DEVELOPMENT REVIEW COMMITTEE (DRC) COMMENT REPORT

PROJECT NAME: WP Aspire Cypress Creek

CASE NUMBER: UDP-S22083

REQUEST: Site Plan Level II Review: Mixed-Use Development with
345 Multifamily Residential Units and 4,519 Square-Foot
Commercial Use in Uptown Project Area

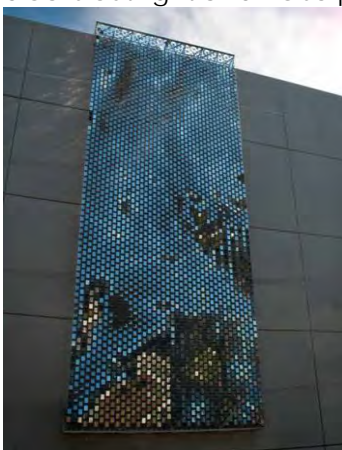
22. Provide a mood board and renderings depicting how the pocket park and plaza space is providing greenery, seating, and other pedestrian friendly elements for use by residents. Incorporate the dog park in the mood board and renderings to determine if the dog park can be counted towards the pocket park requirement. See example image below.

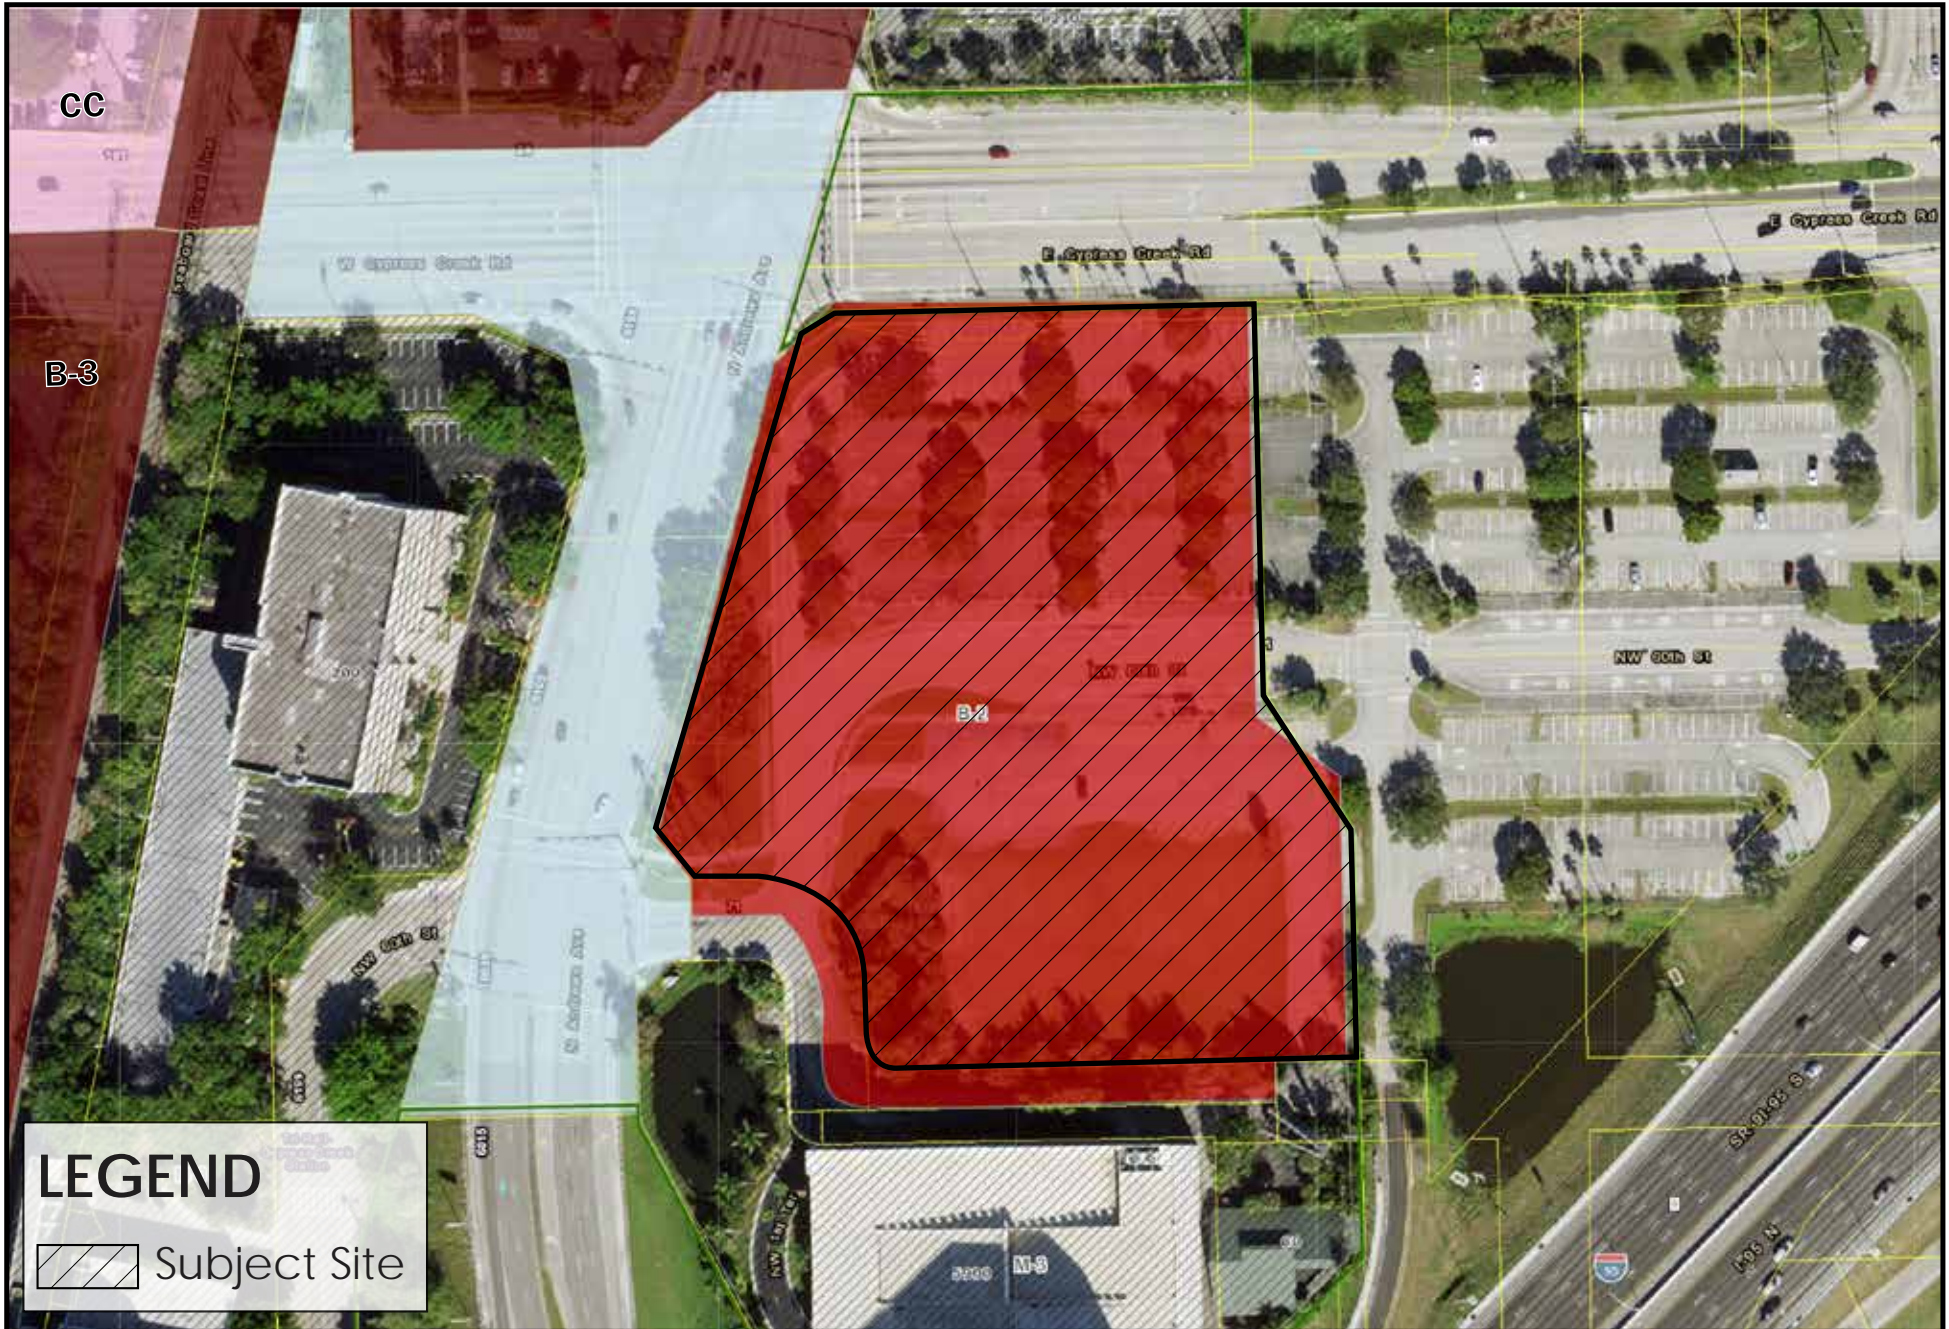
- e. Pursuant to ULDR, Section 47-37B.6.I, Streetscape, as proposed, it does not appear the streetscape on the east portion meets the requirements of this section. Provide detailed cross sections for the interior road facing east, depicting the streetscape zones in relation to the building frontage. Refer to image below.
